REGIONAL REVIEW NOTIFICATION

Name of Proposal: Paces Ferry Commons

Review Type: Development of Regional Impact

Preliminary Report:	Oct 10, 2005	DEVELOPMENT OF REGIONAL IMPACT REVIEW REPORT	Project:	Paces Ferry Commons #825
Final Report Due:	November 9, 2005		Comments Due By:	Oct 24, 2005

V/C Ratios

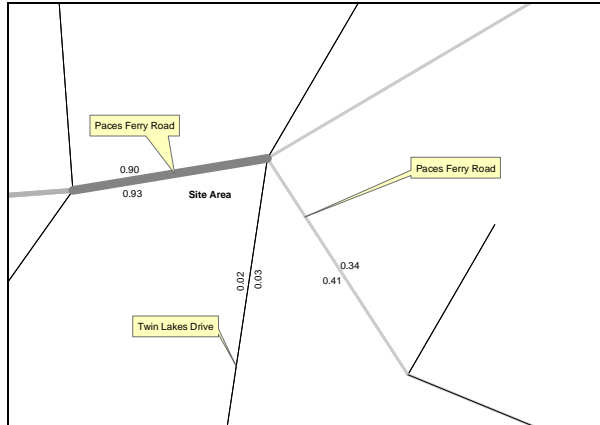
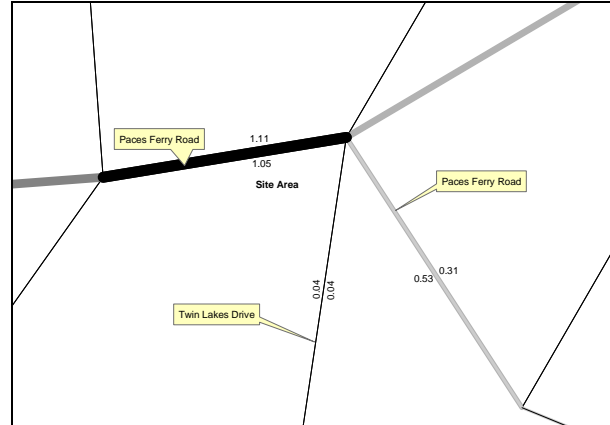
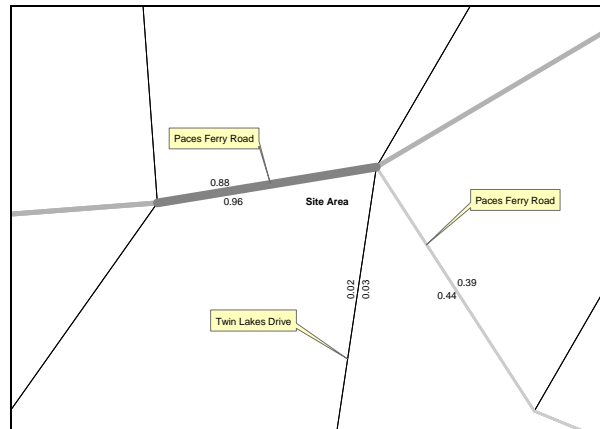
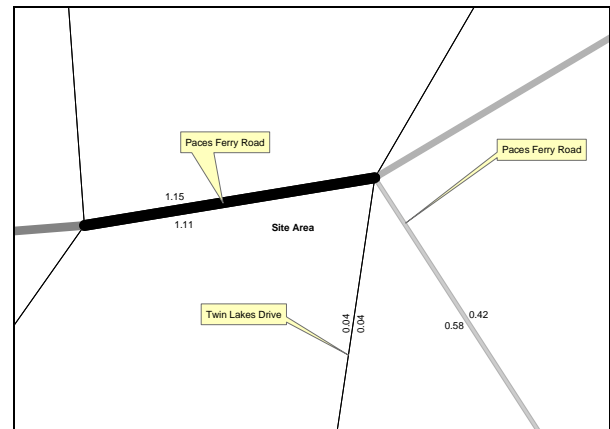
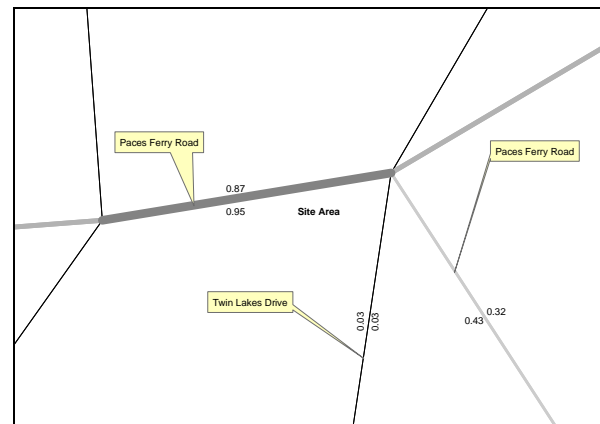
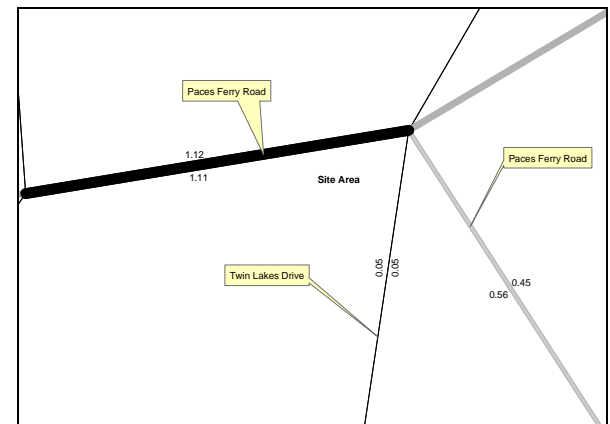
For the V/C ratio graphic, the data is based on 2005, 2010 and 2030 A.M./P.M. peak volume data generated from ARC's travel demand model for Mobility 2030, the 2030 RTP and the FY 2005-2010 TIP, approved in December 2004. The travel demand model incorporates lane addition improvements and updates to the network as appropriate. As the life of the RTP progresses, volume and/or V/C ratio data may appear inconsistent due to (1) effect of implementation of nearby new or expanded facilities or (2) impact of socio-economic data on facility types.
